UNITED STATES PATENT AND TRADEMARK OFFICE

10/626,966

Office Action Summary	Application No. 10/626,966	Applicant(s) DENNIS, WILLIAM G.	
	Examiner TUAN V. NGUYEN	Art Unit 3731

DETAILED ACTION

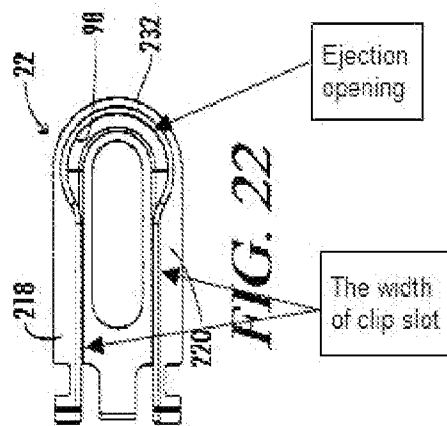
- e. a trigger 16 associated or connected to actuator assembly, which includes actuator lever 184, primary outer tube piston 164, push rod piston 114 and intermediate outer tube 38. The trigger actuates the actuator assembly to actuate jaw push tube 18 to actuate the jaw 20, 22 open or close and moving clip pusher 102 to move a clip into the jaw 20, 22 (see col. 11, line 14 to col. 12, line 15). In column 11, lines 45-50 Shipp discloses when trigger 16 is squeezed and actuator lever 184 begins to pivot, force is immediately simultaneously applied to begin closing the jaws and to begin pushing the clips and there is a slight delay in the beginning of movement of the clips due to the compression of spring 125. Examiner contends that "slight delay" is equivalent to the limitation of "discontinuous" as required in claims 31 and 42. Further, Shipp discloses the rear portion of pusher rod piston 114 is engaged with spring 125 (col. 9, lines 38-40 and Figs. 2 and 4). When the trigger 16 is squeezed the actuator lever 184 begins to pivot, force is immediately applied to the primary outer tube piston 164 to slide forward to begin closing the jaws 20 and 22 (Figs. 2 and 4 and col. 10, line 55 to col. 11, line 5), which is interpreted as the first stage/force, then force applied on the trigger 16 is continued to increase to compress the spring 125, after some compression of spring 125 the movement of

clips in the magazine 58 is begin, which is interpreted as the second stage/force (col. 11, lines 40-45).

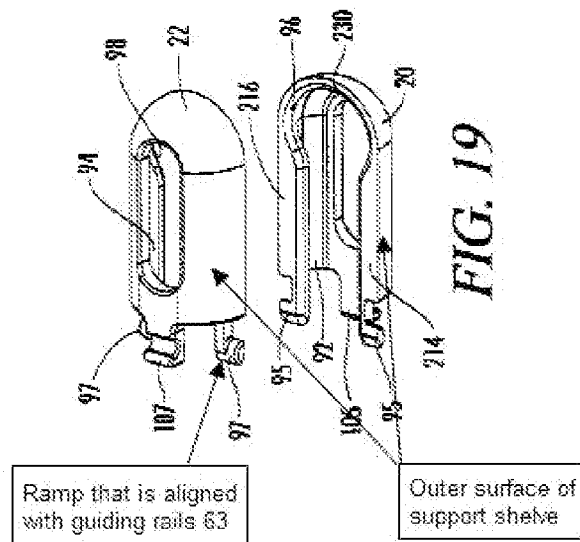
18. Referring to **claims 32 and 53**, Figure 22 (reproduced and annotated below) shows the jaw has a clip slot terminates in an ejection opening 98 adjacent the distal jaw end 232, the clip slot having a slot width and the ejection opening having an ejection opening width that is greater than the slot width.

19. Referring to **claims 71 and 72**, Figure 19 of Shipp's drawings shows jaw 22 includes a pair of ramps 97 for connecting the jaw to the distal end 101 of clip holder 58, wherein each ramp includes outer surfaces that aligned with the respective support rails 61 and 63 of the clip holder 58 (see Figs. 15 and 16) and are continuous with the outer surfaces of the respective support shelves (see Fig. 22 reproduced and annotated below).
